REV B

ALTERATIONS & ADDITIONS
Unit 25, 37-38 East Esplanade Manly NSW
Lot 25 Sec SP 3035

PROJECT STAGE
Development Application

DOCUMENT TITLE
Area Calculations - GFA

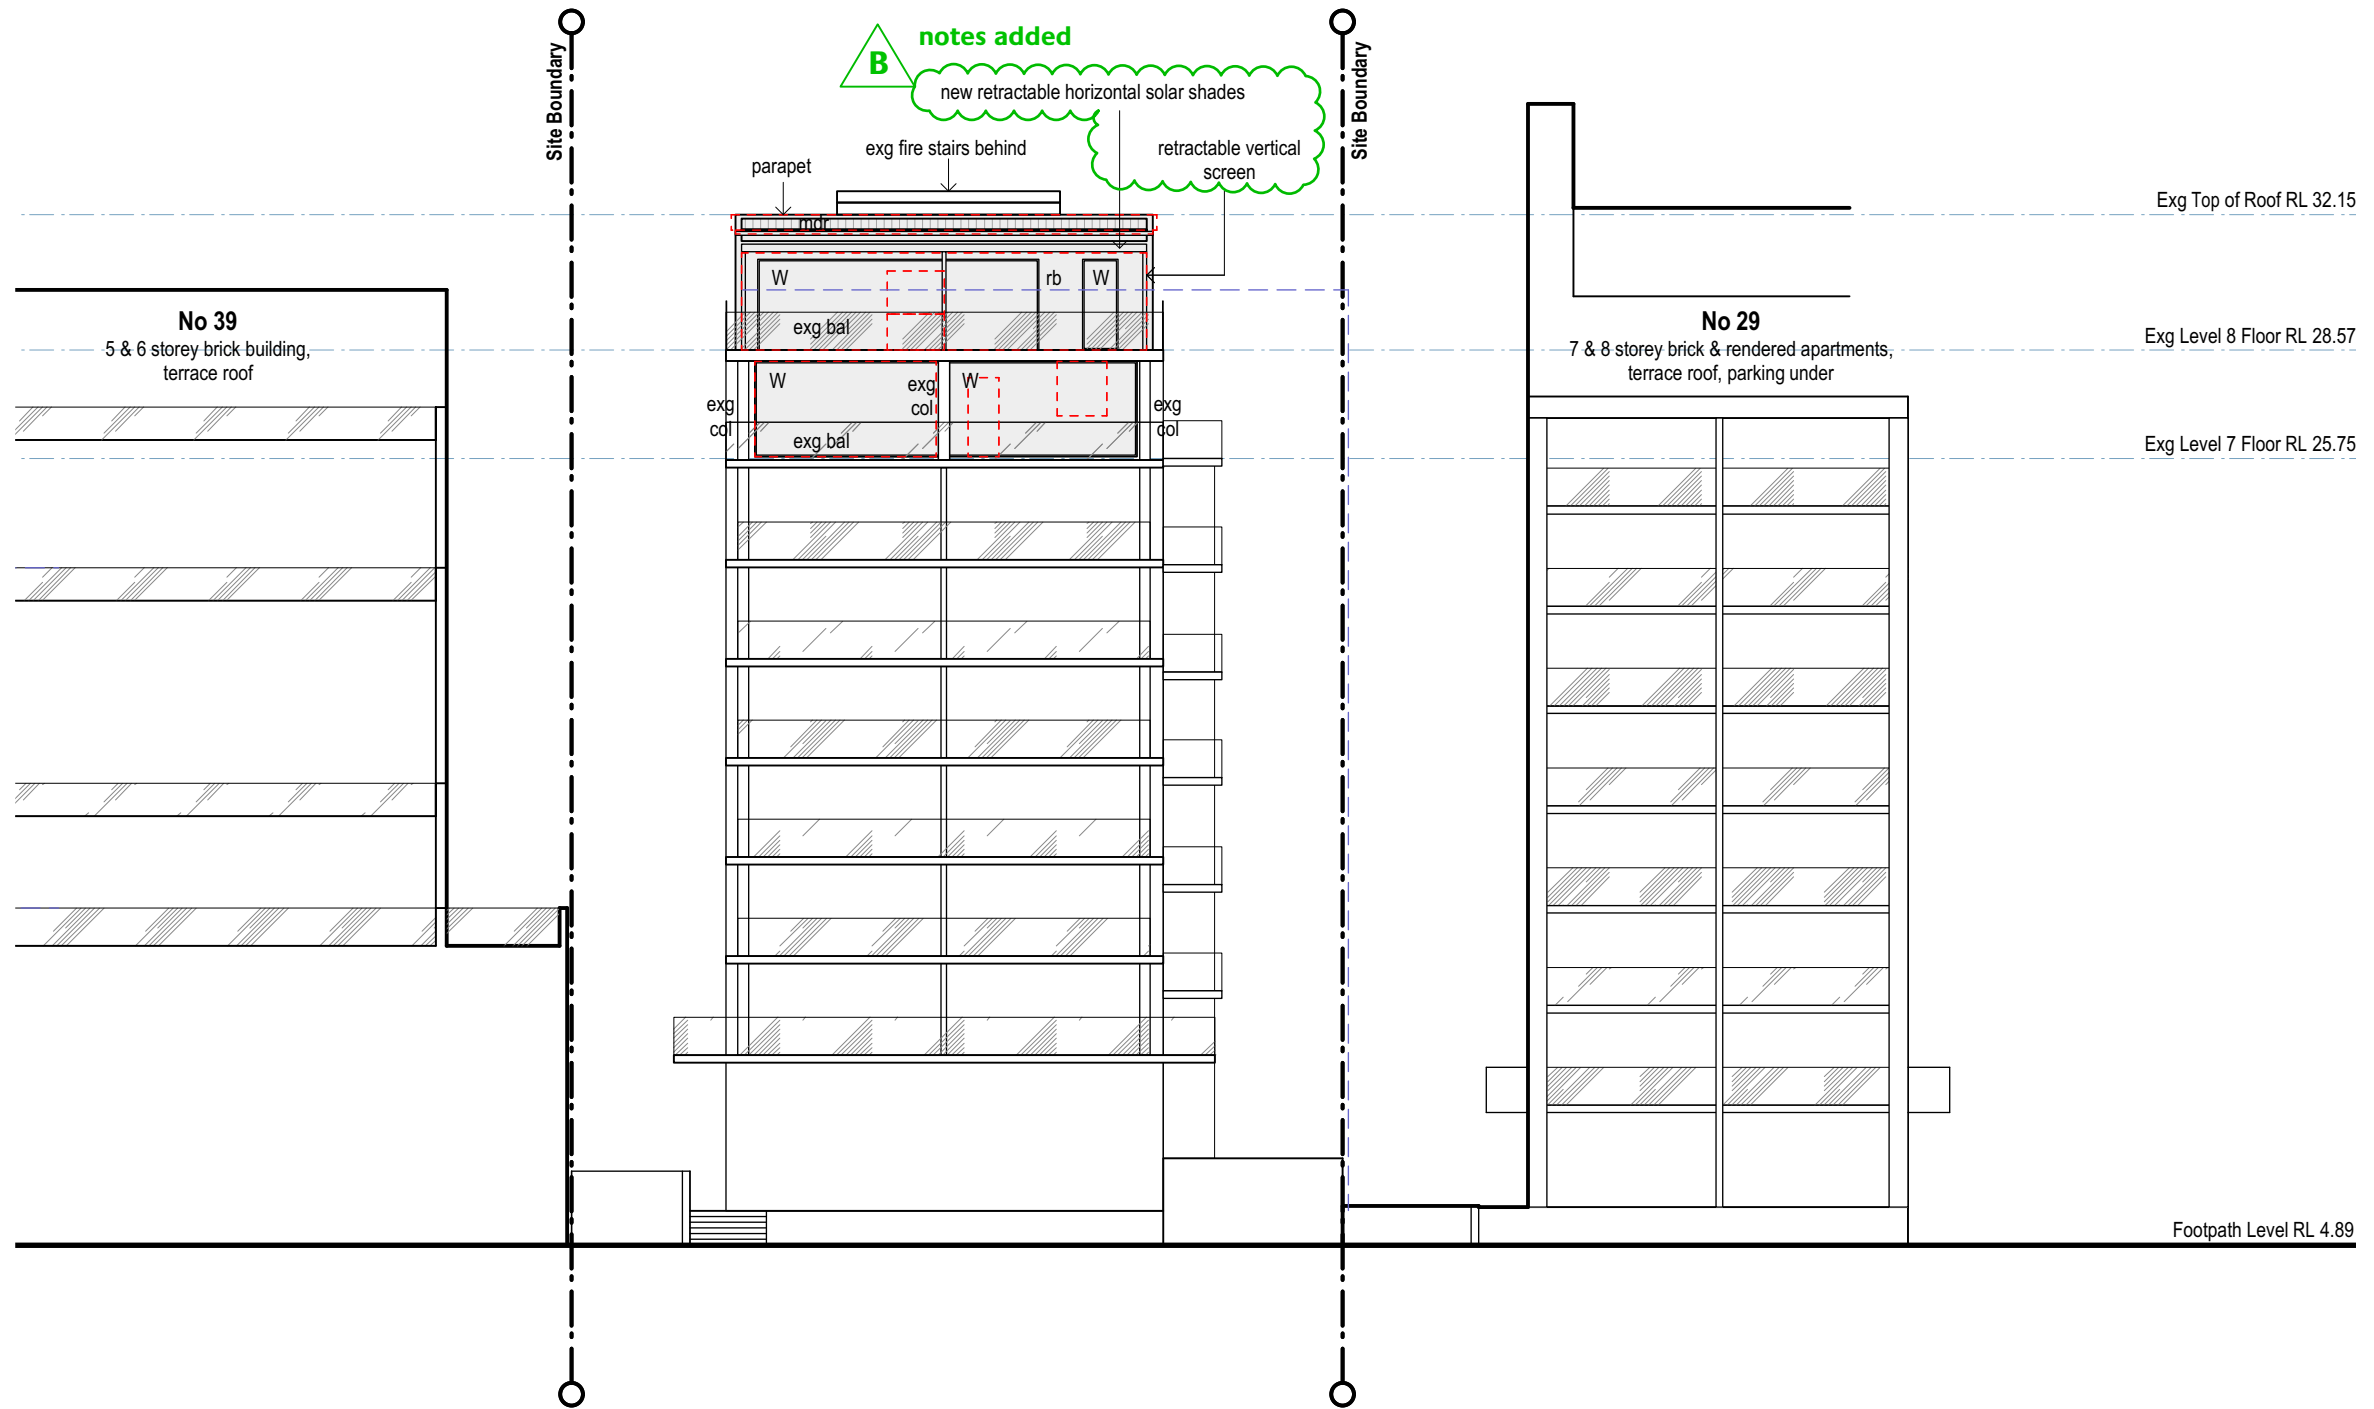
B area calc amended

1.892:1 (1898.9 m² GFA)

1.908:1 (1914.7 m² GFA)

DOCUMENT TITLE
**Proposed South- West Elevation
(Street View)**

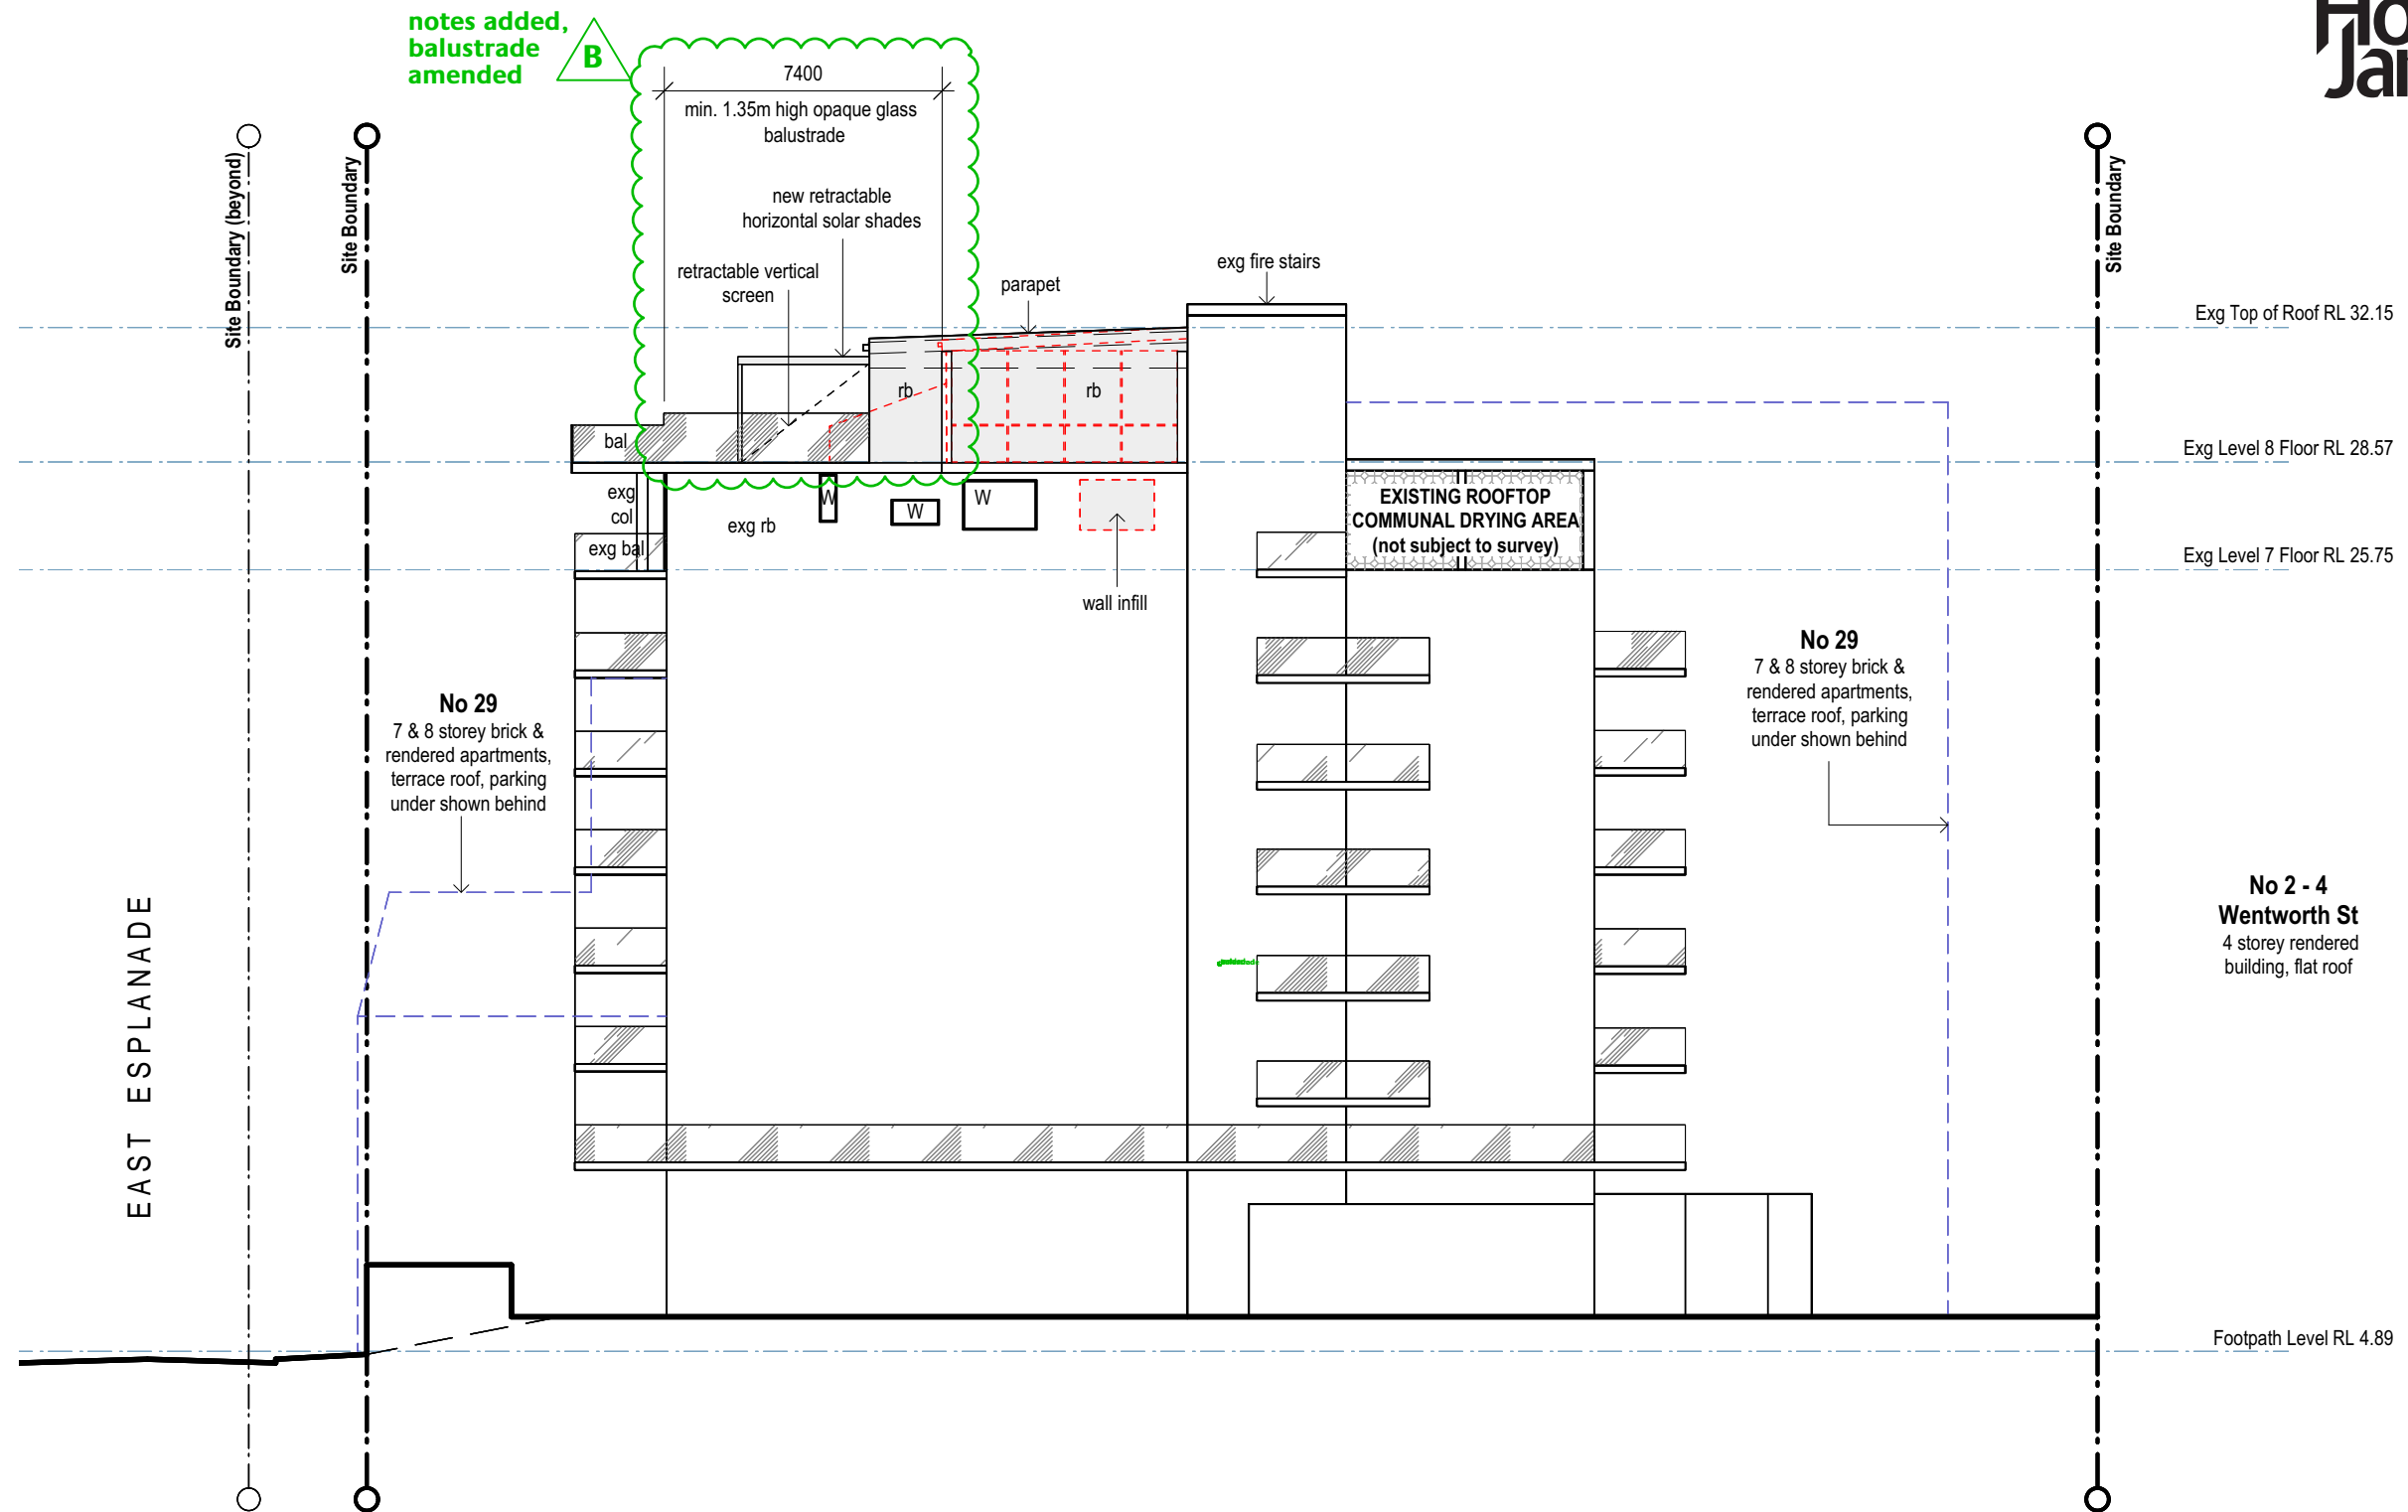
amended and added materials

- 1. Prefinished Metal Roof Sheetting
Colour: standard Colorbond (medium range)
- 2. Opaque 1.35m high glass balustrade
- 3. Rendered and painted brickwork to match existing
Finish: Dulux Paint
Colour: to match existing (TBC)
- 4. Face Brickwork
- 5. New aluminium framed external windows and doors
Finish: White - to match existing
- 6. New skylight
- 7. New retractable horizontal solar shades
Colour: (TBC)
- 8. New retractable vertical privacy screen
Colour: (TBC)
- 9. clear glass balustrade

DOCUMENT TITLE
Shadow Diagrams - Elevational

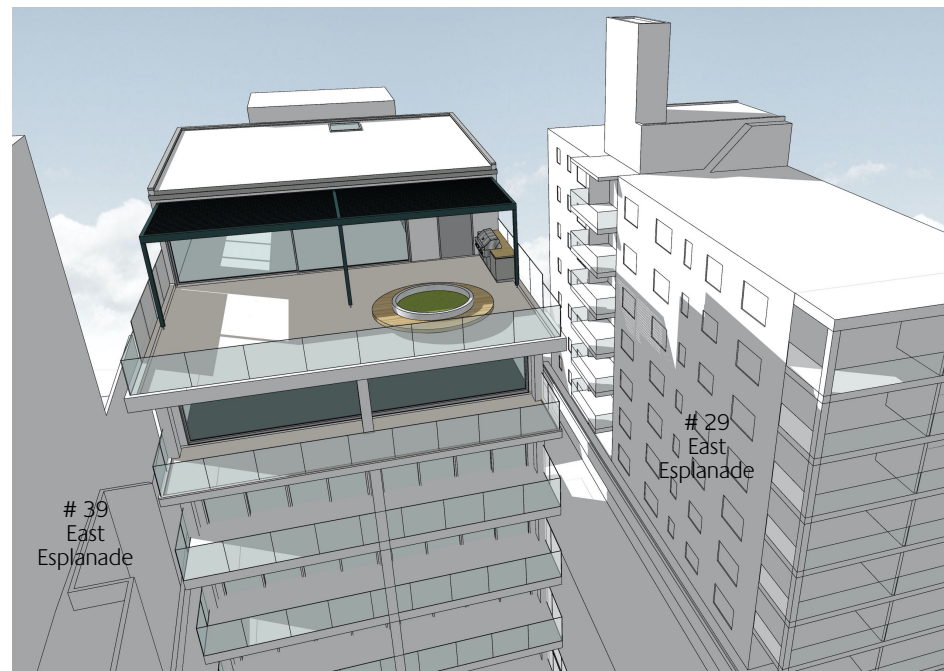
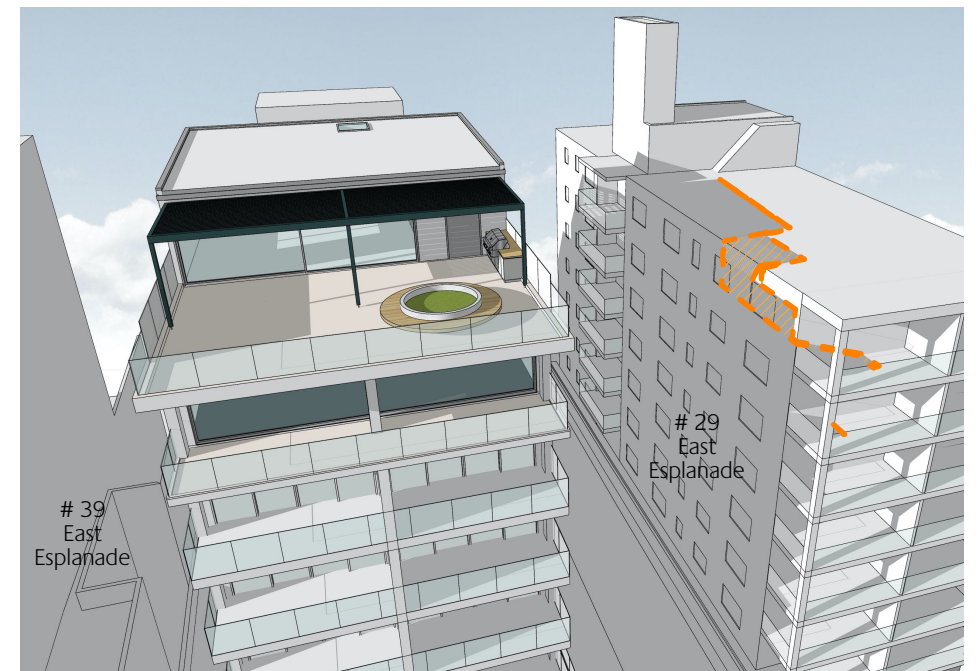
B updated proposed shadows
